## VOLUME 8: COMPLIANCE AND ENFORCEMENT

### 8.0 COMPLIANCE AND ENFORCEMENT

### 8.1 COMPLIANCE ASSISTANCE

Figure 3: Leakage from Reciprocating Compressor Units in "Not Operating--Depressurized" Mode

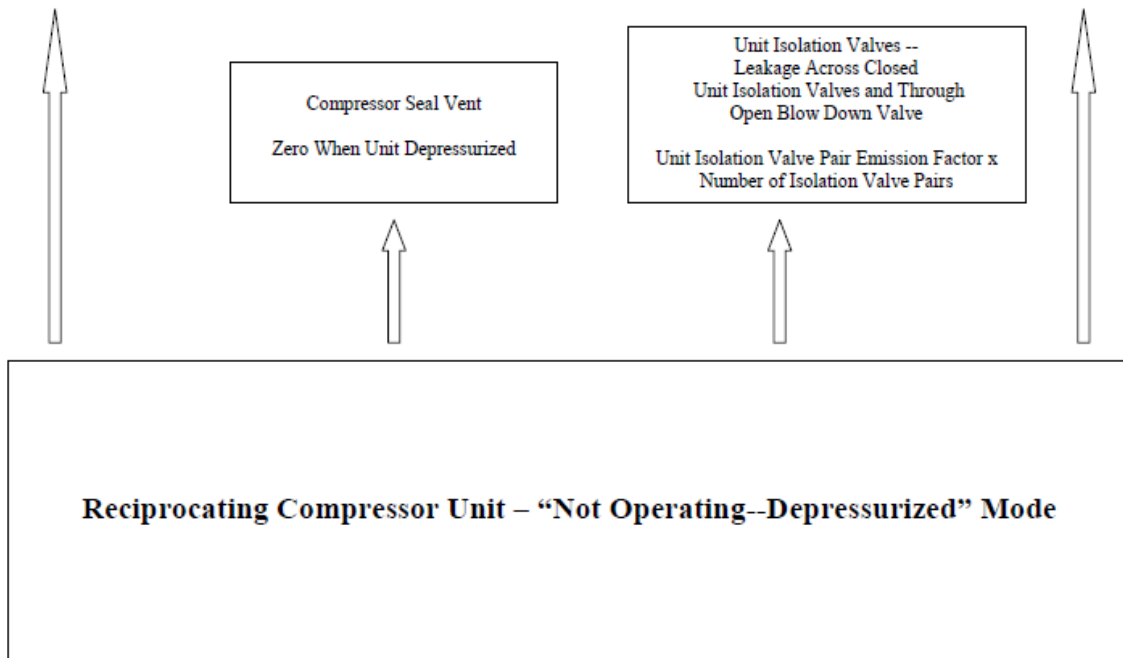
Figure 3 represents the leakage from a reciprocating compressor unit that is in the “Not Operating – Depressurized” mode. When a unit is depressurized (blown down), the only source of leakage will be through the unit isolation valves, which are closed in order to isolate the unit from the main pipeline. Leakage through these valves travels through the open blow down valve and is measured at the blow down vent. The leakage in this case is calculated pursuant to Equation 3:
